Overview

Staff's Role

Drawdown Analysis

Figure 6. Cooper-Jacob Analysis for the Big Gulch Stock Well with Water-Level Trend Corrections

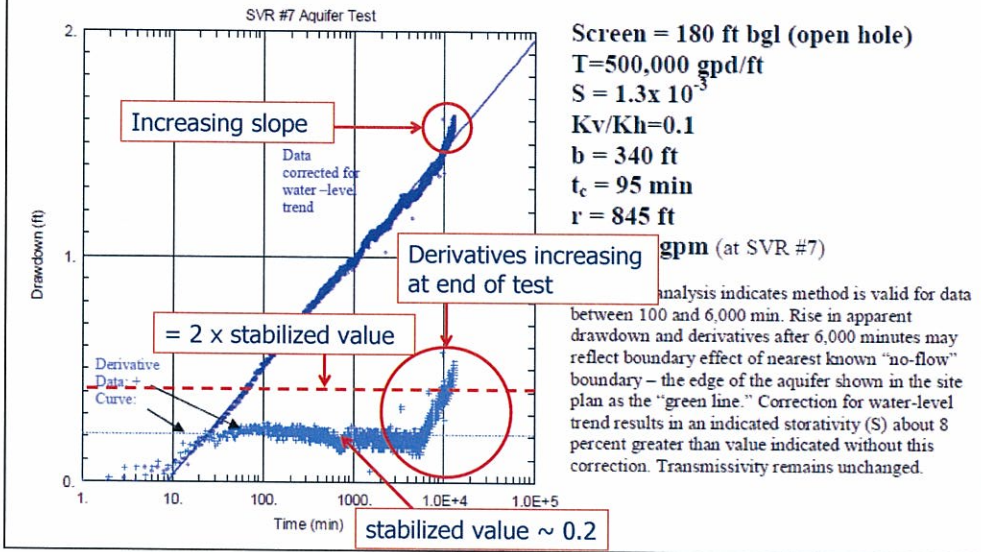
Let me show you what I'm talking about. This is Figure 6 from Exhibit 45. It's a plot of trend-corrected drawdown versus the logarithm of time in the monitoring well closest to the test well. The increase in the slope of the data trend that I've identified with the upper red circle is diagnostic of the cone of depression encountering a negative hydraulic boundary, as is the increase in the value of the derivatives, which I've identified with the lower red circle. All external influences have already been removed from these data so there doesn't appear to be a more plausible explanation. The drawdown plot clearly shows that the aquifer test ended while the slope of the data was still changing and, equivalently, the value of the derivative was still increasing. Ending the test while those things are occurring is contrary to the goal of establishing boundary conditions in order to assess long-term performance of the aquifer. The fact that the derivative values have increased by more than a factor of two is cause for concern to staff because, although inconclusive, it suggests that the drawdown data possibly were being affected by more than one hydraulic boundary.

EXHIBIT 44

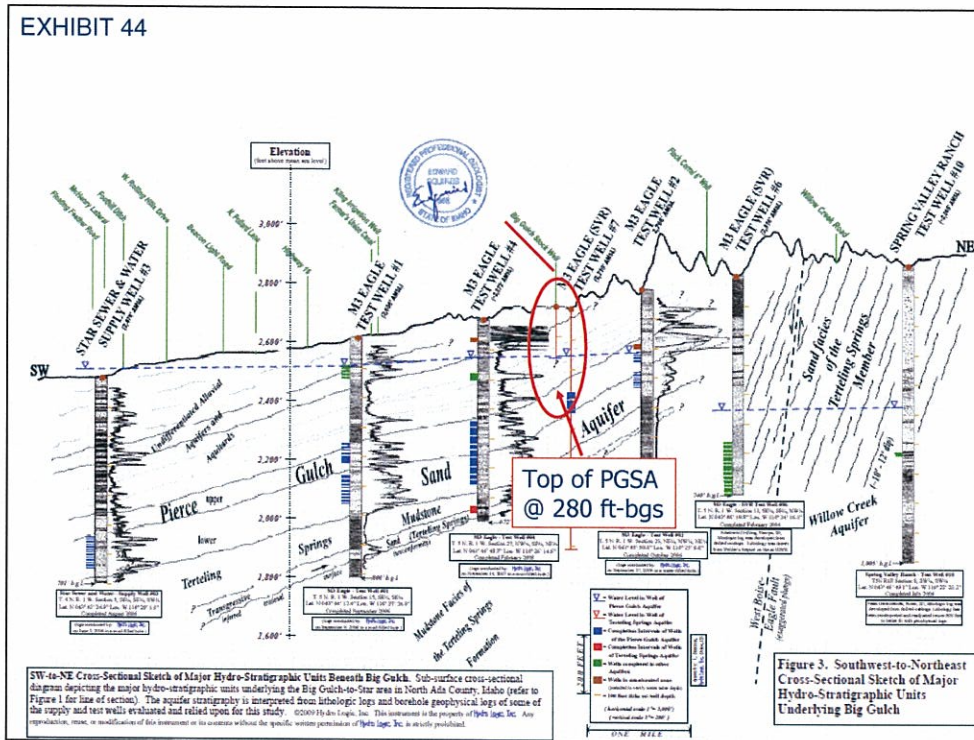
Here is Figure 3 from the same report. The PGSA beneath the Big Gulch test well on this cross-section is shown at a depth of 280 feet, which agrees with the reference in the text to there being a 100-foot difference between the total depth of the well and the top of the aquifer, which I've identified with a red arrow on the cross-section.

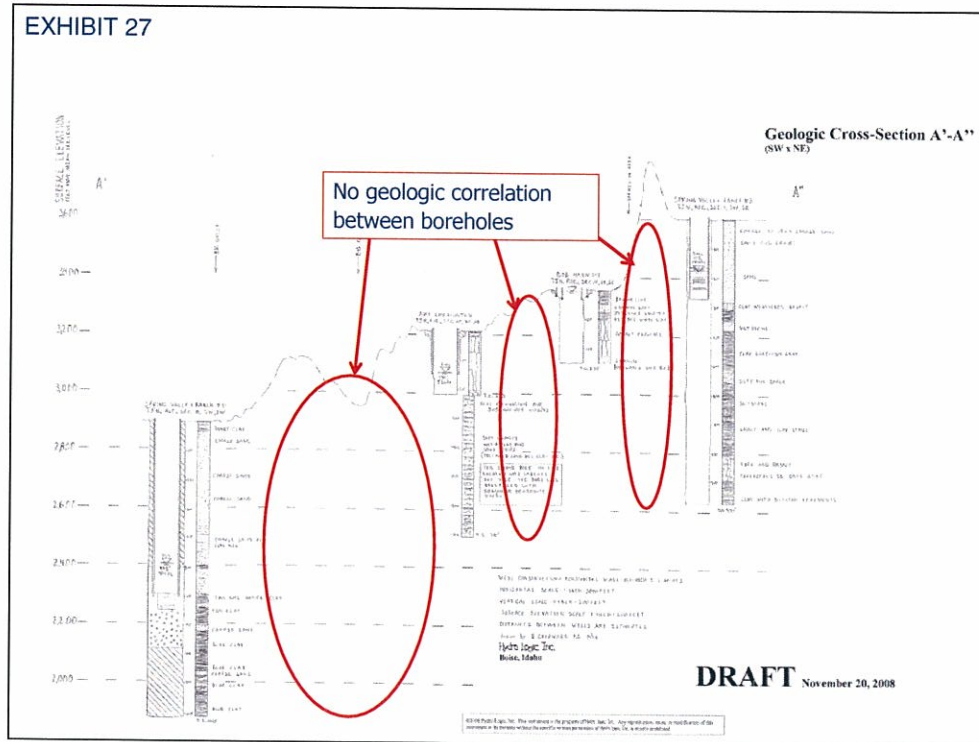
- Complexity suggested by seven layer flow model w/ 3 layers used to represent the PGSA

Beyond what's been written in the supporting documentation, I think the fact that the M3 flow model comprises seven layers, 3 of which are used to represent the PGSA, is, in and of itself, a fairly convincing argument that the hydrostratigraphy in the area is complex. Consider, for example, that the Department has implemented conjunctive management for the eastern Snake Plain using a 1-layer flow model and M3's model is used to describe groundwater flow in only a portion of the smaller western Snake Plain.

Figure 5. Geologic Cross-Section through the M3 Eagle Site

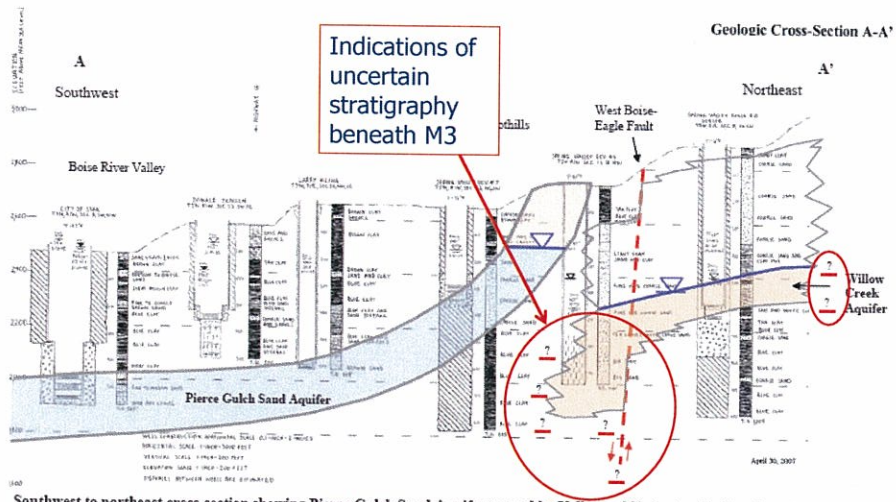
This geologic cross-section is Figure 5 from the Year 1 Progress Report, Exhibit 2. The section runs from the southwest to the northeast through Big Gulch on M3 property. Question marks are used between SVR#7 and SVR#6 to indicate uncertainty in the stratigraphic relationships between these wells, both of which occur on the same side of the West Boise-Eagle Fault. That indication of uncertainty suggests that the stratigraphy beneath M3 is complex.

Figure 5. Geologic Cross-Section through the M3 Eagle Site

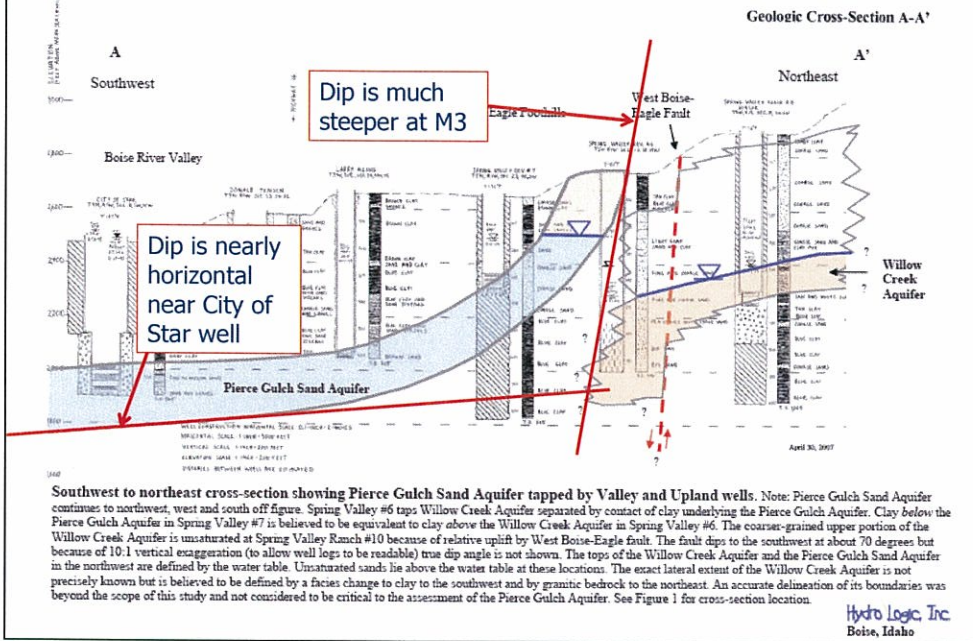
Also notice this depiction of the PGSA from Exhibit 2 as having concave upward top and bottom structures with a continuously increasing dip as you move further to the northeast, which is to the right on this diagram. I've added red lines to show how the dip of the contact between the PGSA and the underlying Terteling Springs Formation dramatically increases as you move further along section and away from the center of the basin. The nearly horizontal red line represents the dip of the contact near the City of Star well and the much steeper solid red line illustrates that the dip is thought to be much steeper near the intersection of the PGSA with land surface. As far as I know, this stratigraphic complexity is not discussed in the supporting documentation.

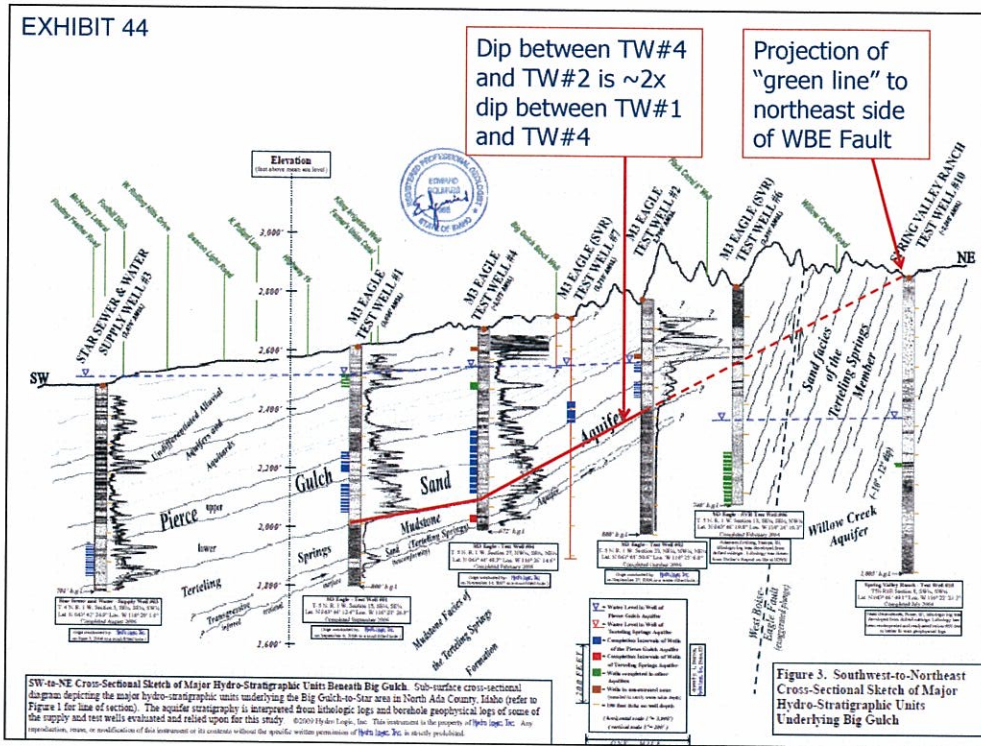
Notice now that the finalized version of this same section, Figure 3 from Exhibit 44, shows a somewhat different but also difficult to explain interpretation in which the dip of the PGSA bottom structure between TW#4 and TW#2 is more than double the slope of the bottom structure between TW#1 and TW#4. Note that the projection of the contact between the PGSA and the underlying mudstone using the steeper dip would cause the so-called green line to be located well to northeast side of SVR#6. In fact, the projection of the contact, which I've drawn on the figure using a dashed red line, intersects land surface near SVR#10, which is northeast of the West-Boise Eagle Fault.

EXHIBIT 44

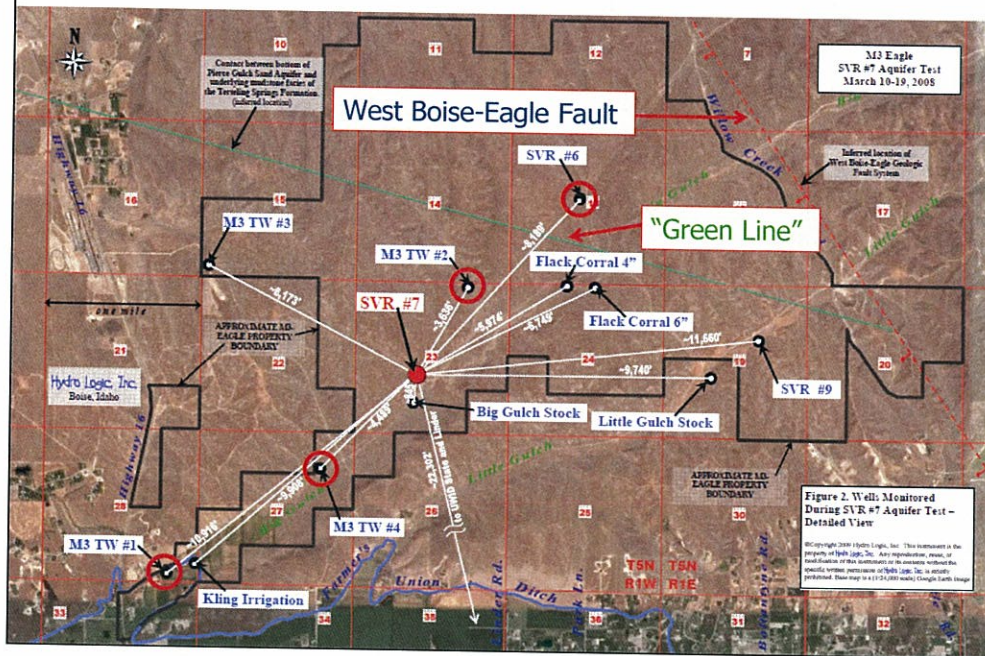
However, this is contrary to the inferred location shown on Figure 2 in Exhibit 44, the SVR#7 Aquifer Test Report. The green line is instead shown on the southwest side of the West Boise-Eagle fault which would require an even steeper dip between TW#2 and SVR#6 than the already increased dip that was shown on the last slide. A slight steepening might be expected as you move closer to the sediment source but the increase in dip necessary to keep the green line on the west side of SVR#6 is dramatically greater and, as I mentioned, the geologic mechanism that would cause this to occur is not explained in the supporting documentation.

Figure 5. Geologic Cross-Section through the M3 Eagle Site

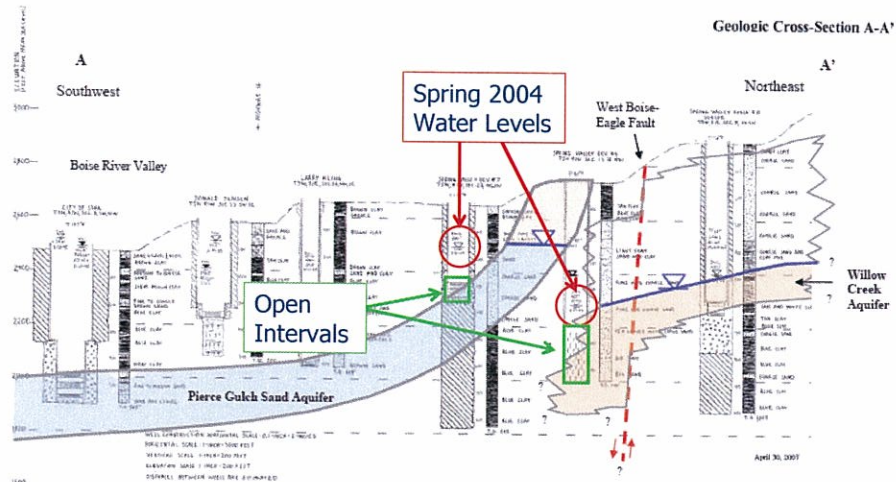
I'd like now to go back to Figure 5 in Exhibit 2, which is the Year 1 Progress Report. Notice that this figure shows an abrupt water level change between SVR#7 and SVR#6 – the water level in the shallower SVR#7 well is roughly 200' higher than in the well with a deeper completion interval, SVR#6. The fact that this significant water level difference appears to occur on the same side of the known West-Boise Eagle fault also is contrary to our expectations based on the information that we've been provided. A much lower water level in the deeper well might be expected on opposite sides of a no-flow barrier but it is not expected between wells on the same side of a fault, especially in an area where, as Mr. Squires testified, there is supposed to be an upward hydraulic gradient. The cause for the dramatic change in dip and apparent strong downward hydraulic gradient are not explained in the HLI submittals and suggests to staff that the hydrostratigraphy beneath the M3 property is complex. I should also point out that the pronounced downward vertical gradient is not explained by the so-called green line because the aquifer underlying the PGSA is laterally continuous in the southwest direction according to the conceptualization shown on this figure. Based on my experience characterizing and modeling faulted, fluvial-deltaic aquifers in Texas, a plausible explanation for what's going on between SVR#7 and SVR#6 is that the stratigraphic section is cut by an unidentified fault, which most likely parallels the West Boise Eagle fault. This possibility could dramatically change the significance of the so-called green line on the hydrogeology beneath M3.

EXHIBIT 45

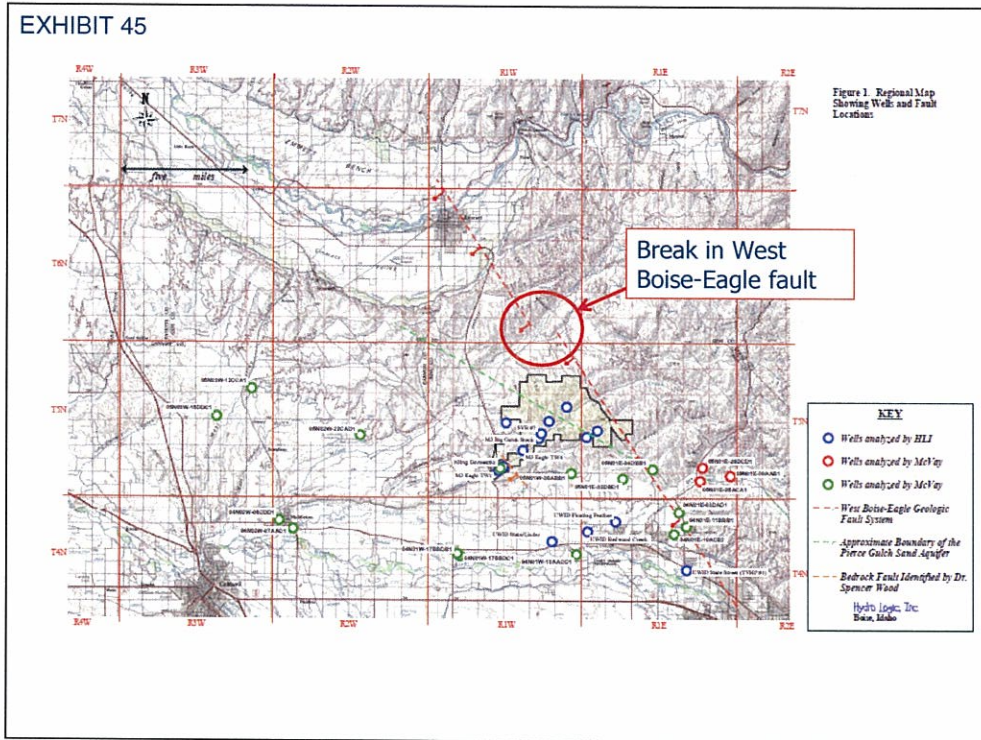
Additional complexity is revealed by looking at Figure 1 from the Response to our Staff Memorandum, Exhibit 45. There is a break in the West-Boise Eagle Geologic Fault north of M3 in the area that I've circled in red. I'm not sure whether the offset was caused by a transverse fault or some other mechanism but, whatever the cause, the nonlinearity of this feature complicates the hydrogeology of the PGSA since it transects both the shallow and deep strata.

EXHIBIT 45

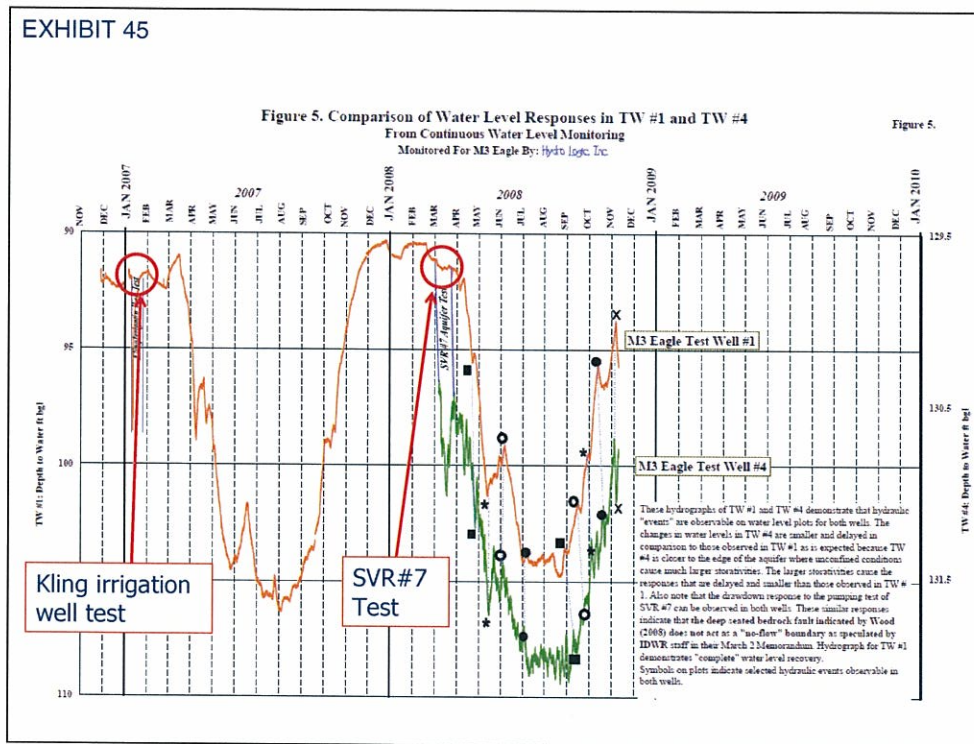
Here is Figure 5 from HLI's Response to the Staff Memorandum. The labeling by HLI indicates that the water levels in TW#1 are the orange data and that the water levels in TW#4 are the green data. I've identified the water levels in TW#1 during the Kling Irrigation and SVR#7 tests by drawing red circles around those data. Note that the maximum water level change is such a small fraction of 1 foot that it's almost imperceptible during both the Kling irrigation and SVR#7 aquifer tests. It's therefore difficult to determine based on looking at this figure whether or not there was any drawdown in TW#1 during either test. Further complicating interpretation of this figure is the fact that TW#1 is a nested piezometer, which monitors water levels at 5 different elevations. According to Table 1 in Exhibit 44, which is the SVR#7 aquifer test report, none of the five zones responded to pumping during the SVR#7 test. And according to page 200 of Exhibit 12, the shallowest piezometer, Zone 5, "did not react at all to pumping". The text on page 205 from the same report indicates that the minimum end-of-test drawdown among the other four TW#1 piezometers was 6.5 ft in Zone 1. Because Figure 5 from the Response to the Staff Memorandum indicates almost imperceptible drawdown during the Kling irrigation test and the smallest drawdown in any of the four zones that did respond to pumping was 6.5 ft, the only logical interpretation is that the orange line represents the water levels in Zone 5 of TW1, which like the Kling domestic well, is identified by HLI as being completed in the shallow alluvial aquifer system. It's difficult to reconcile HLI's conclusion that the water level in TW#1 recovered within two weeks with indications that the water level in Zone 5 did not respond to pumping in either of M3's aquifer tests. The indication from the aquifer test reports is that there was no water level decline from which to recover.

Figure C-3. Actual and BE-Corrected Water Levels for Big Gulch Stock Well

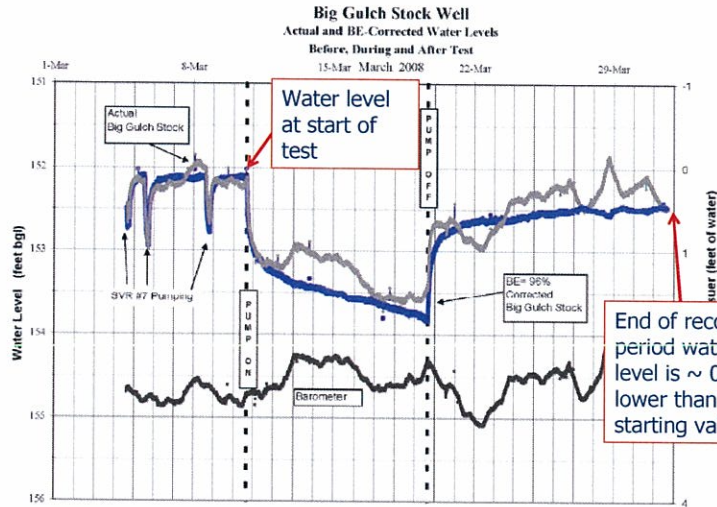
I want to focus now on the SVR#7 aquifer test. This hydrograph is Figure C-3 from Exhibit 44, which is the SVR#7 Aquifer Test Report. It's an arithmetic plot of water level versus time. The blue colored data are the water levels after correcting for barometric pressure fluctuations. The period of monitoring encompasses the period of pumping and water level recovery. You can see that the water levels decline quickly in response to the onset of pumping on March 10, 2008 and they partially recover in response to the pump being shut off on March 19. In our Staff Memorandum, we expressed concern with the fact the water levels in the Big Gulch Stock well, which again was the closest monitoring well to the SVR#7 test well, and the only observation well to have more than 1-foot of drawdown during the 9-day test, did not appear to be trending toward full recovery. Note that the water level at the end of the water level recovery period, twelve days after the pump was shut off, was approximately four tenths of a foot lower than the water level that was measured immediately prior to turning on the pump. Incomplete or delayed water level recovery are concerns to staff because they can be indications that the aquifer is of limited extent.

Figure 26. Theis Recovery Analysis for the Big Gulch Stock Well with no Water-Level Trend Correction

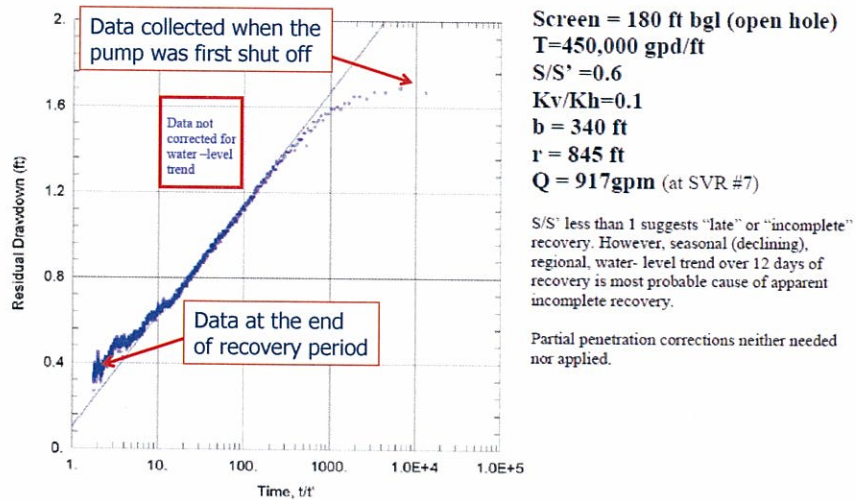
This is Figure 26 from Exhibit 44, the SVR#7 Aquifer Test Report. The water level recovery data from the previous figure have now been plotted in the standard format for quantitative analysis, which is as residual drawdown, the difference between the original pre-test water level and the water level during recovery, versus the logarithm of the ratio t/t' , the time since pump was turned on, divided by t' , the time since the pump was turned off. Note that the data on this plot have not yet been corrected for the regional water level trend. The main thing I want to point out about this plot is that the first data to be collected after the pump shut off are the blue colored dots in the upper right hand part of the plot and the data in the lower hand portion of the plot are the last recovery data that were collected so the recovery time increases to the left. Also note that the ending residual drawdown values are approximately four-tenths of a foot which means the water levels at the end of the recovery period are four-tenths of a foot lower than the pre-pumping level. That's the same determination that I made for the previous slide because these are the same water level data - they've just been plotted differently to facilitate analysis.

Figure 27. Theis Recovery Analysis for the Big Gulch Stock Well with Water-Level Trend Corrections

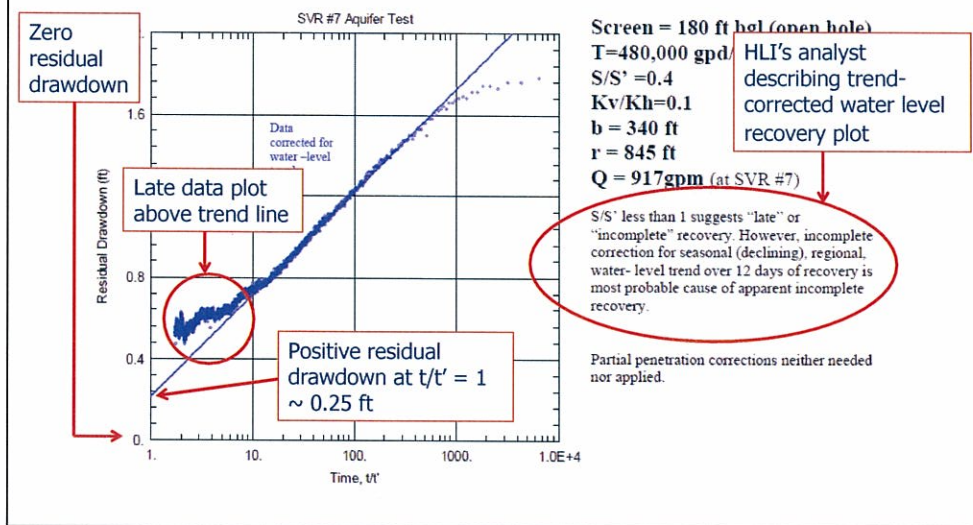
This is Figure 27 from Exhibit 44, the SVR#7 aquifer test analysis report. This plot is of the same data one more time, only now they have been corrected for the water level trend. Our review of this diagram was the basis for our comment about the apparent failure to achieve water level recovery in the Big Gulch Stock well. That conclusion was based not only on the ending residual drawdown values, which are slightly more than half of a foot on this diagram, but the fact that the data trend is not toward zero residual drawdown but instead is toward a positive residual drawdown of approximately one-quarter of a foot. The positive, non-zero intercept is diagnostic of an aquifer of limited extent and that is a major concern for staff in the context of evaluating the sustainability of the resource. HLI's analyst acknowledged the possibility of late and/or incomplete recovery in the caption on the right side of the figure. It says *"S/S' less than 1 suggests late or incomplete recovery. However, incomplete correction for seasonal, declining, regional water-level trend over 12 days of recovery is most probable cause of apparent incomplete recovery."*
